# Addendum No. 1

## CSI Diesel Mechanics Facility

## Addendum 1

Project: CSI: Automotive/Agricultural Diesel Mechanics Facility

RING ROAD  
PLAN &  
PROFILE

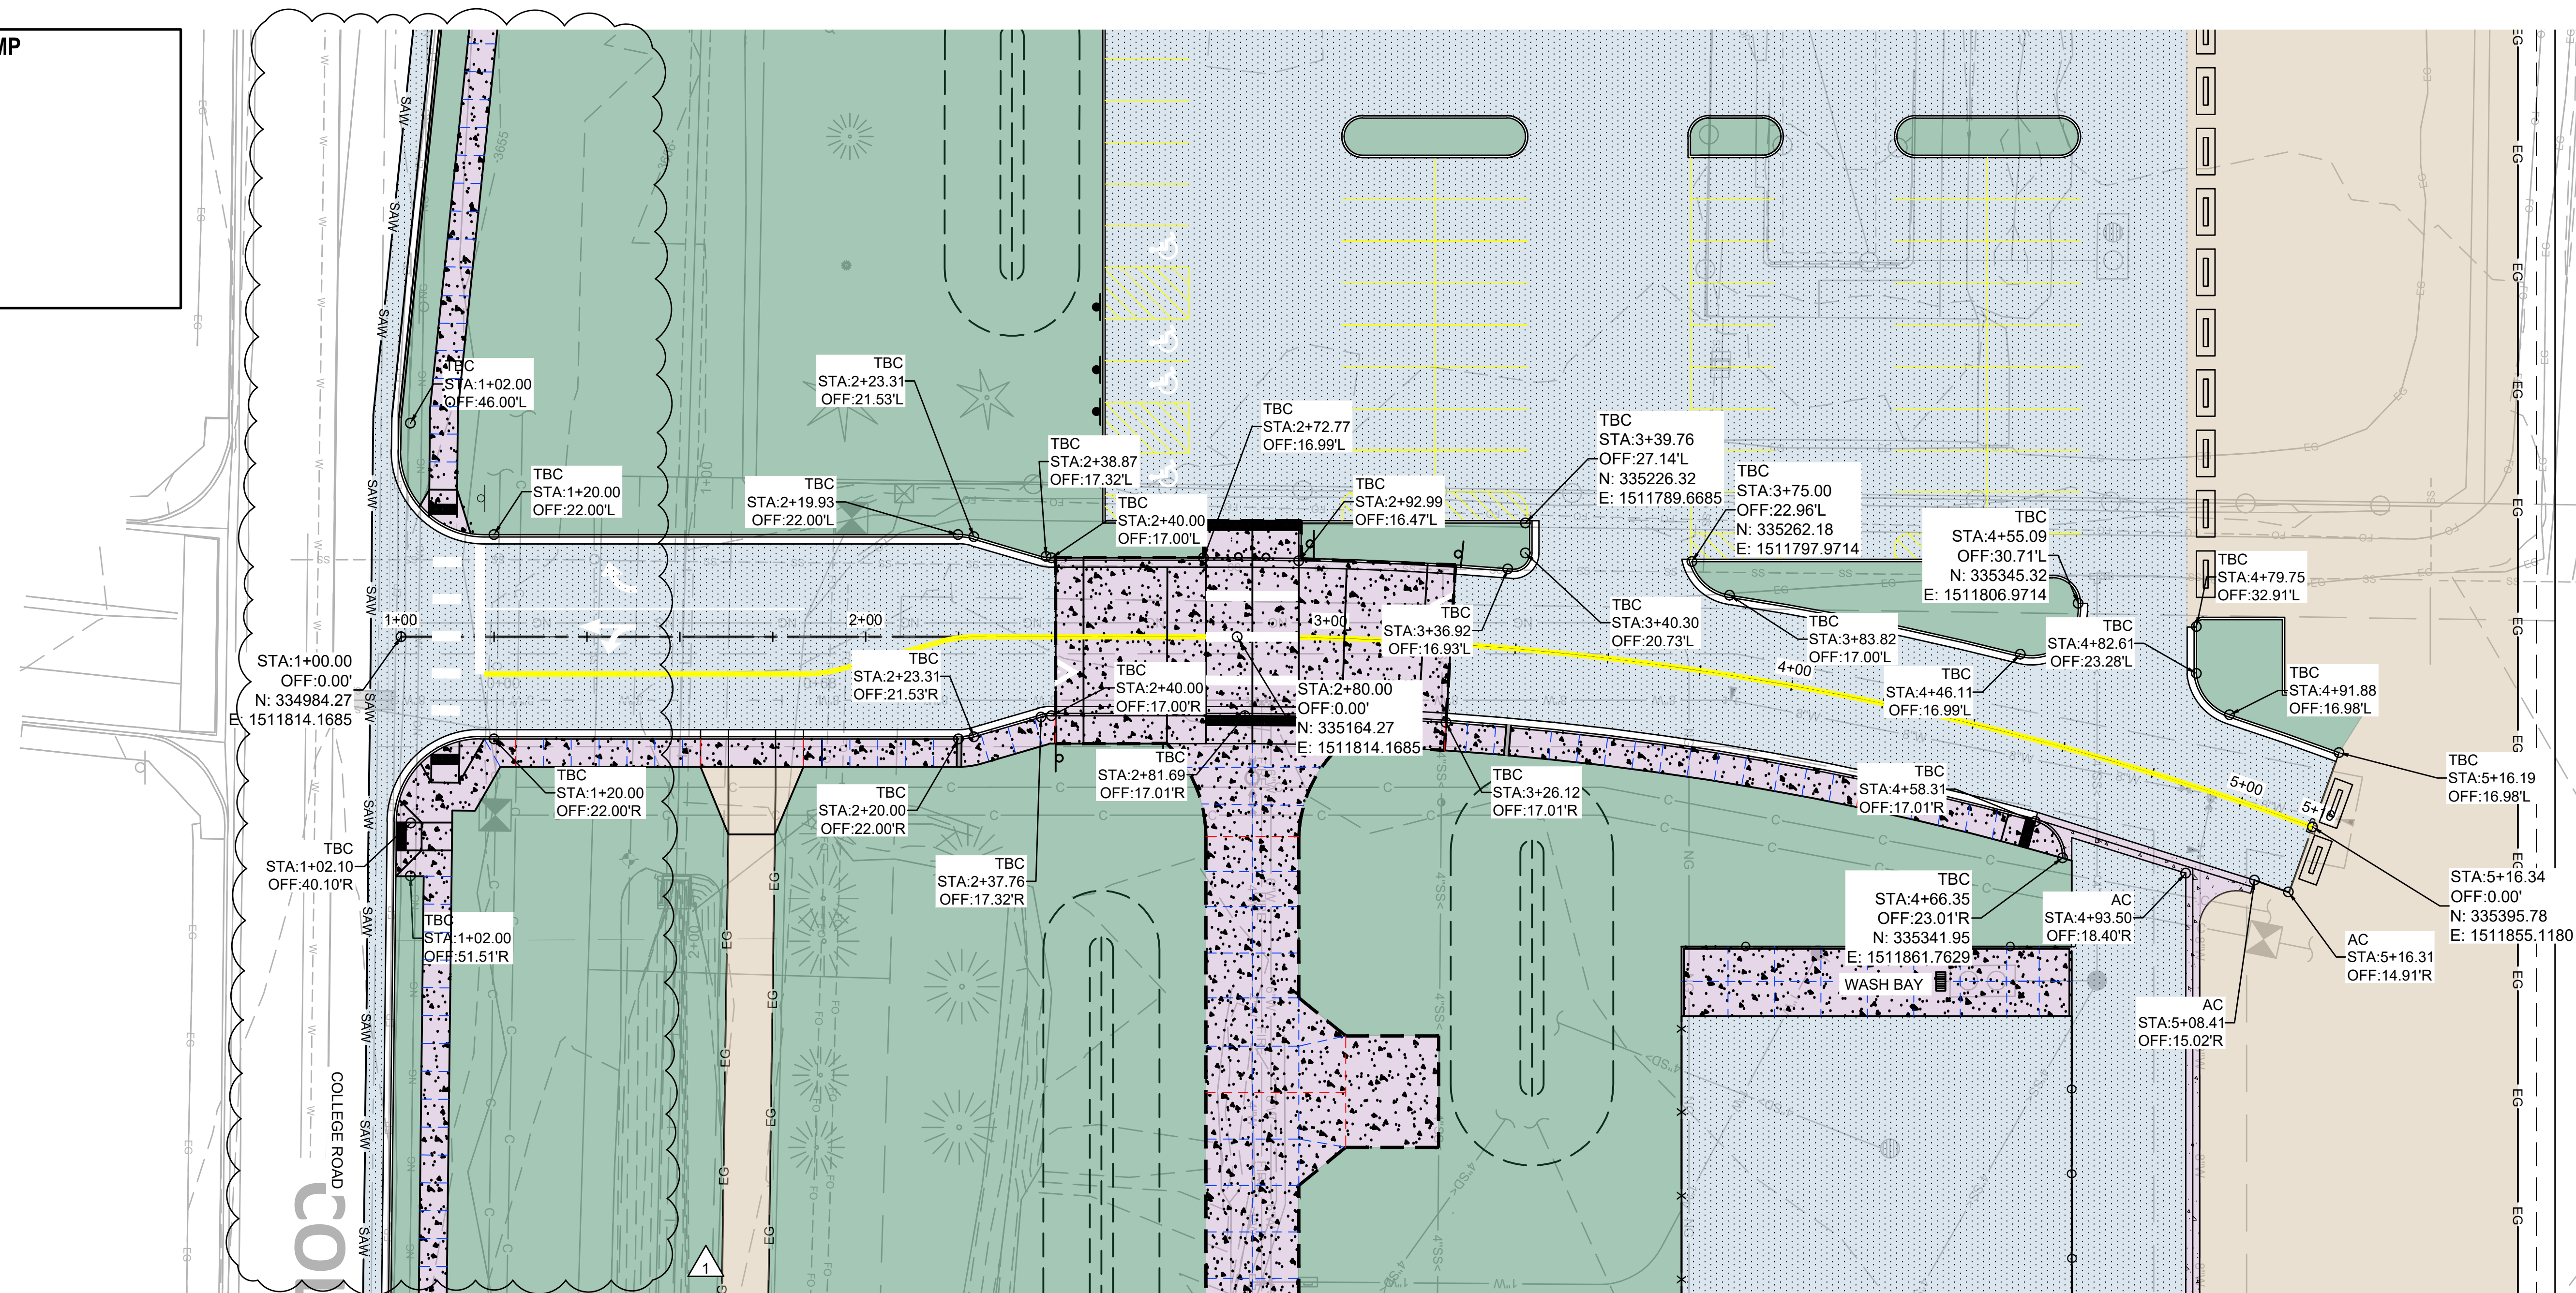
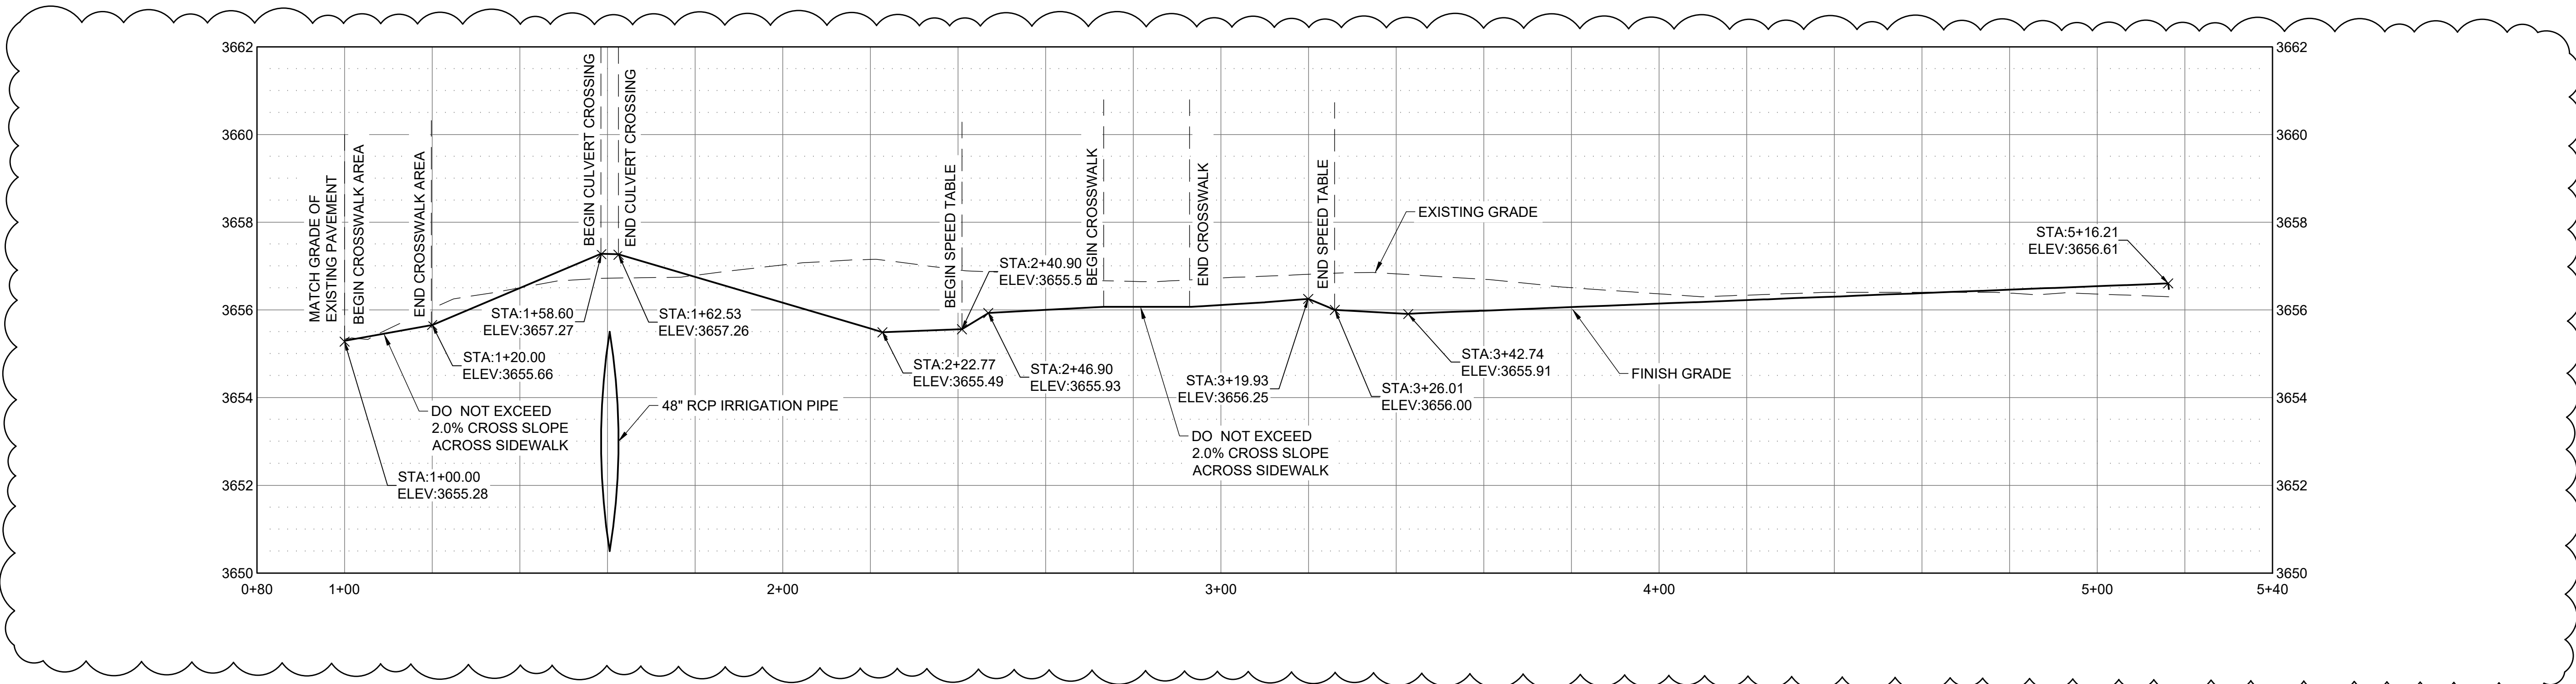
Item #C4      C300 - RING ROAD PLAN & PROFILE  
 Add. #1      Grade across E-W crosswalk revised to accommodate ADA grades along city frontage improvements.

**CIVIL UTILITY PLAN**

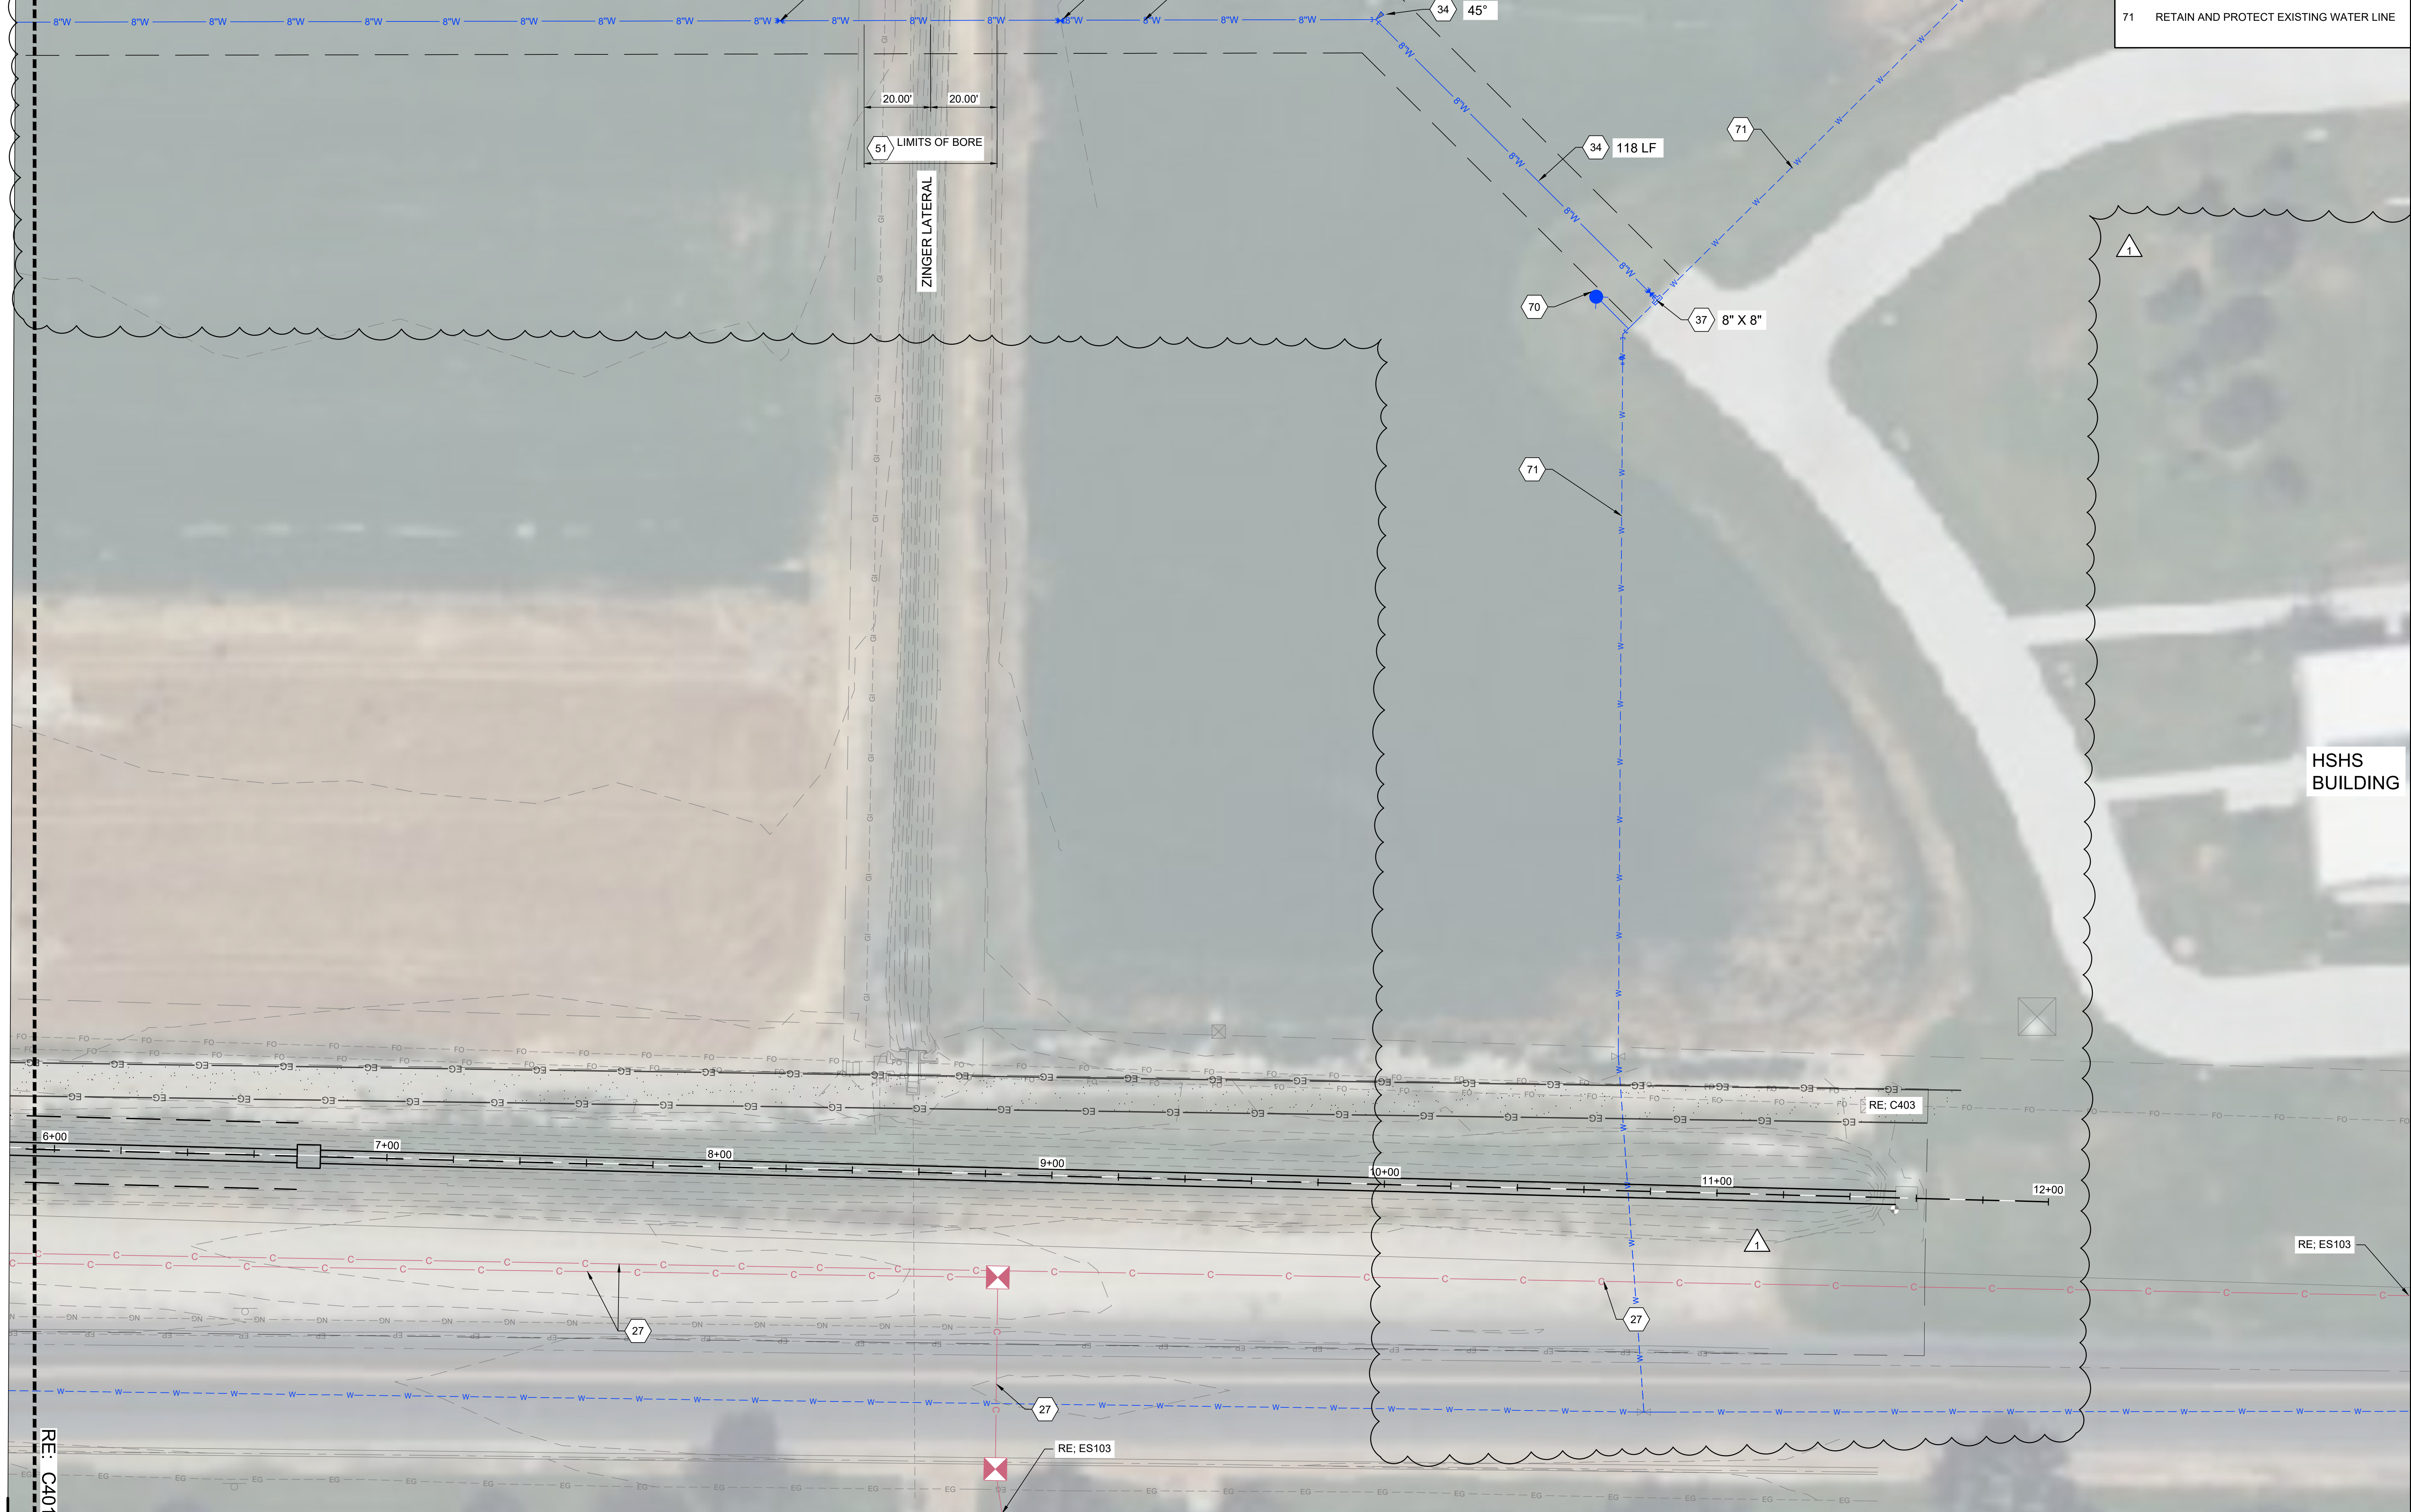
Add. #1 Waterline alignment updated to add waterline loop connection at HSHS building.

**CIVIL UTILITY PLAN**

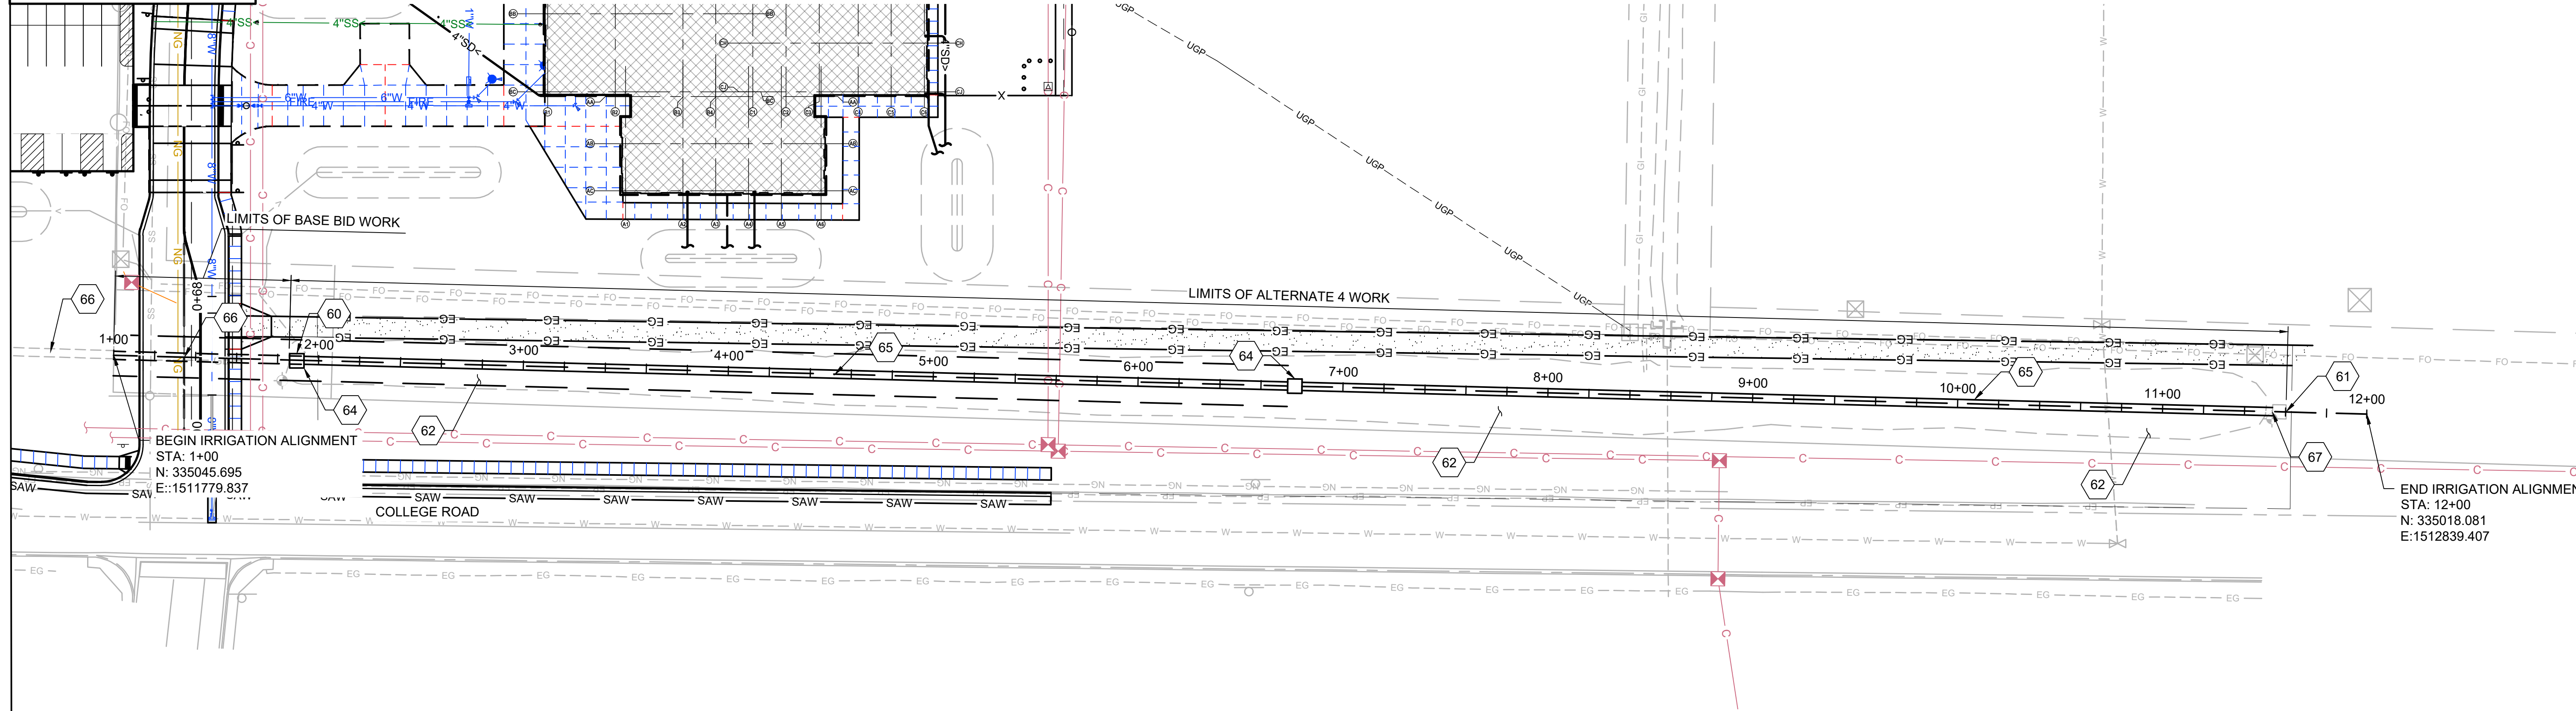
Add. #1 Waterline alignment updated to add waterline loop connection at HSHS building.
